REDUCED WIDE OPEN THROTTLE RPM 225 HP, (3 LITRE) EFI

1995 and 1996 225 HP, (3 Litre) EFI

S/N 0G129222 thru end of 1996 Model Year

53636

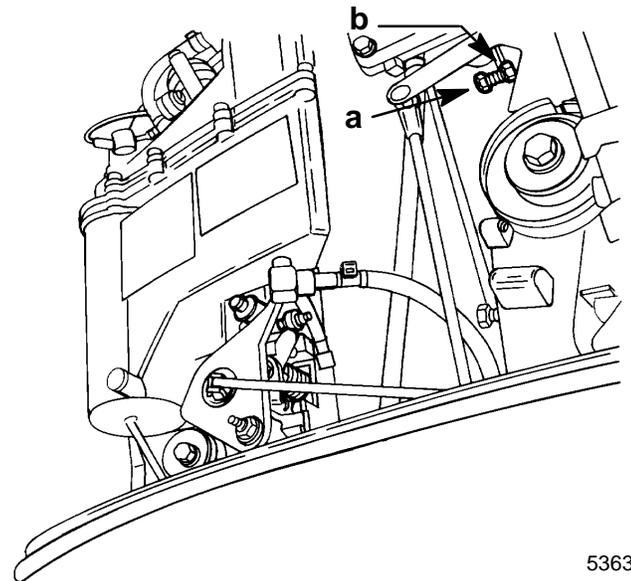
3. Connect RED voltmeter lead to Red lead of test harness assembly and BLACK voltmeter lead to WHITE lead of test harness assembly for a TPS measurement. Set voltmeter to 20 VDC.
4. Turn ignition key to "ON" position.
5. Disconnect the throttle cable from the throttle arm.
6. Loosen the full throttle stop screw jam nut.
7. Hold throttle arm against full throttle stop screw.

a - Full throttle stop screw
b - Jam nut

8. While holding the throttle arm at wide open throttle, adjust the throttle stop screw to attain a voltmeter reading of $2.94 \pm .04$.

9. Tighten jam nut.

53330

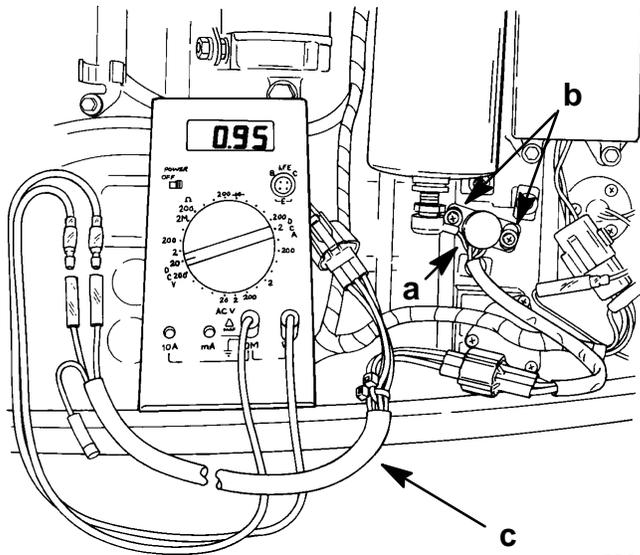
NOTE: Do not adjust TPS to attain this reading. TPS reading must remain at .95 at idle.

- a - Throttle position sensor
- b - TPS set screws
- c - TPS/CDM test harness p/n (84-825207A1)
